Access Compliance Report

Public Rights-of-Way

(Curb Ramps)

Intersection ID: 10027310	Main Street: GLENEAGLES_RD	Cross Street: N/A	Location: SE
ADA ID: 578D0941EC34	Ramp Type: PerpDiag	Initial Pass/Fail: Fail	Overall Compliance: No
Severity Score: 8.75			
Codes/Mitigation Info/Possible Solution		Field Measurements/Component Compliance

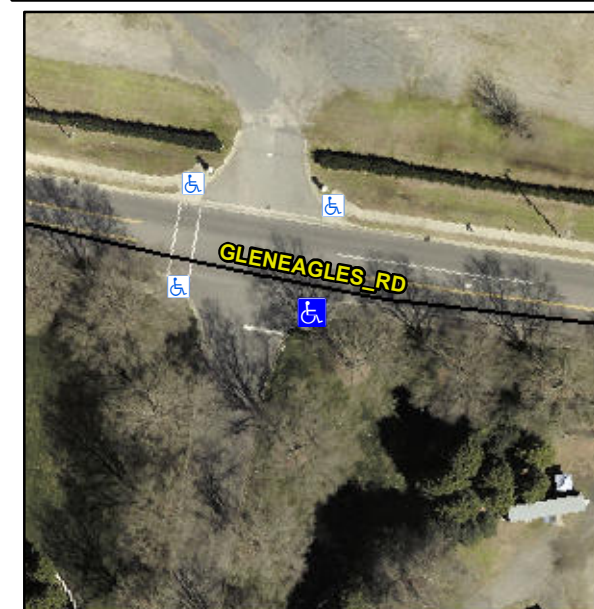
Compliance	Description	Data	Compliance	Description	Data
N/A	Ramp Length (in)	74.0	Yes	Ramp Slope (%)	5.8
No	Ramp Width (in)	38.0	Yes	Ramp XSlope (%)	0.6
N/A	Flare Type LT	N/A	N/A	Flare Type RT	N/A
N/A	Flare Slope LT (%)	N/A	N/A	Flare Slope RT (%)	N/A
N/A	Flare Traversable LT?	N/A	N/A	Flare Traversable RT?	N/A
N/A	Landing Length (in)	N/A	N/A	DWS Provided?	N/A
N/A	Landing Width (in)	N/A	N/A	DWS Contrast?	N/A
N/A	Landing Slope (%)	N/A	N/A	DWS Length (in)	N/A
N/A	Landing X Slope (%)	N/A	N/A	DWS Full Width?	N/A
N/A	Landing Curb? (Y/N)	N/A	N/A	DWS Offset (in)	N/A
N/A	Shared Landing?	N/A			
N/A	Gutter Ponding?	N/A	N/A	Gutter Slope (%)	N/A
N/A	Gutter Lip Ht (in)	N/A	N/A	Gutter X Slope (%)	N/A
N/A	Painted X Walk1?	No	N/A	Painted X Walk2?	No
	X Walk 1 Direction	To N		X Walk 2 Direction	To NW
N/A	X Walk 1 Width (in)	N/A	N/A	X Walk 2 Width (in)	N/A
	X Walk 1 Slope (%)	3.5		X Walk 2 Slope (%)	3.2
	X Walk 1 X Slope (%)	2.7		X Walk 2 X Slope (%)	5.7

N/A	Ramp inside XWalk1?	N/A	N/A	Ramp inside XWalk2?	N/A
	Road Slope (%)	0.5	N/A	Clear Space?	N/A
	Road X Slope (%)	6.9	N/A	Clear Space to XWalk (in)	N/A
N/A	Any Obstructions?	N/A	N/A	Storm Grate/Utility Hazard?	N/A
	Obstruction Type			Storm Grate/Utility Type	
		N/A			N/A
		Yes		Surface Condition? (G/P)	Good

Remove & Replace Curb Ramp With Two New Directional Ramps or Equivalent.
